**THE PORT AUTHORITY OF NEW YORK AND NEW JERSEY
TWO MONTGOMERY STREET - 1st FLOOR
JERSEY CITY, NJ 07302**

ADDENDUM NO. 13

TO PROSPECTIVE BIDDERS ON CONTRACT **EWR-154.395** – NEWARK LIBERTY INTERNATIONAL AIRPORT – TERMINAL A REDEVELOPMENT PROGRAM BRIDGES N61, N62, N63, AT-GRADE ROADWAYS AND APPURTENANCES AND CONTRACT **EWR-154.395M** – NEWARK LIBERTY INTERNATIONAL AIRPORT – AGREEMENT TO PERFORM LANDSCAPE MAINTENANCE

SKETCH SK-ES01
 ADDENDUM NO. 13

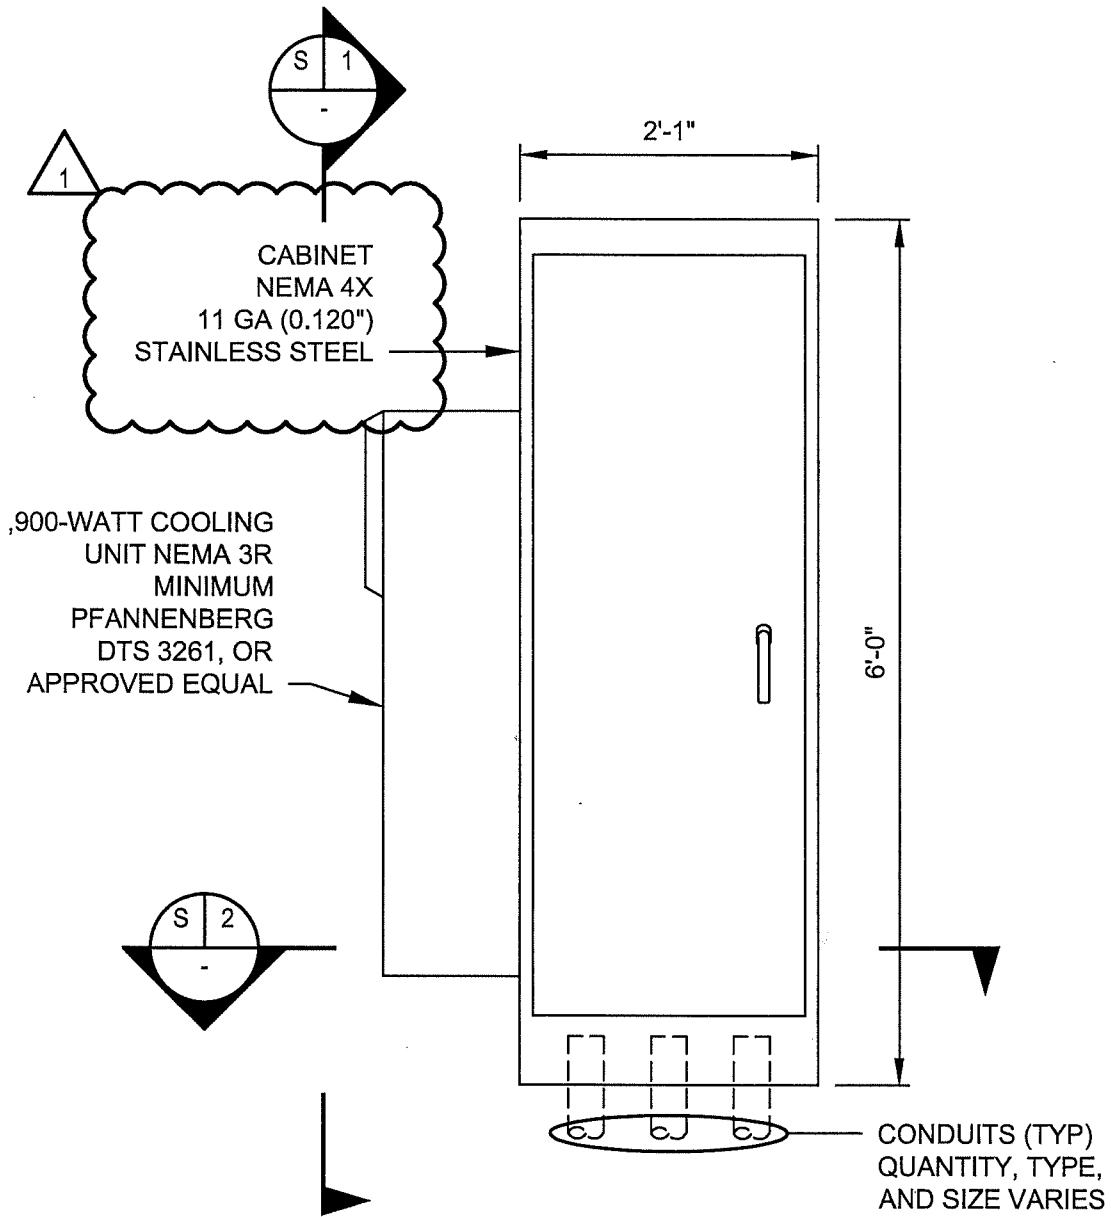
- Dwg. E1202 - Delete the text of Note 4 in its entirety and substitute therefor "FURNISH AND INSTALL A LOAD CENTER WITH RISER BASE. CABINET SHALL HAVE STAINLESS STEEL BACK PANEL, NEMA 3R RATED AND MADE FROM 11 GA (0.120") STAINLESS STEEL. LOAD CENTER SHALL HAVE SLAM LOCK WITH CORBIN #2 KEY. METER CABINET SHALL HAVE "POLICE SLAM LATCH" WITH SKELETON KEY. SUBMIT MANUFACTURER'S SHOP DRAWING FOR THE CABINETS TO THE ENGINEER FOR APPROVAL."
- Dwg. ES0405 - Make the following changes:
- A. Delete the text of Note 1 in its entirety and substitute therefor "EQUIPMENT CABINETS SHALL BE A FREE-STANDING, MINIMUM 11 GA (0.120") STAINLESS STEEL CABINET WITH INTERNAL 19" EQUIPMENT RACKS."
 - B. Revise the drawing as shown in Sketch SK-ES01 which is attached hereto and made a part hereof.
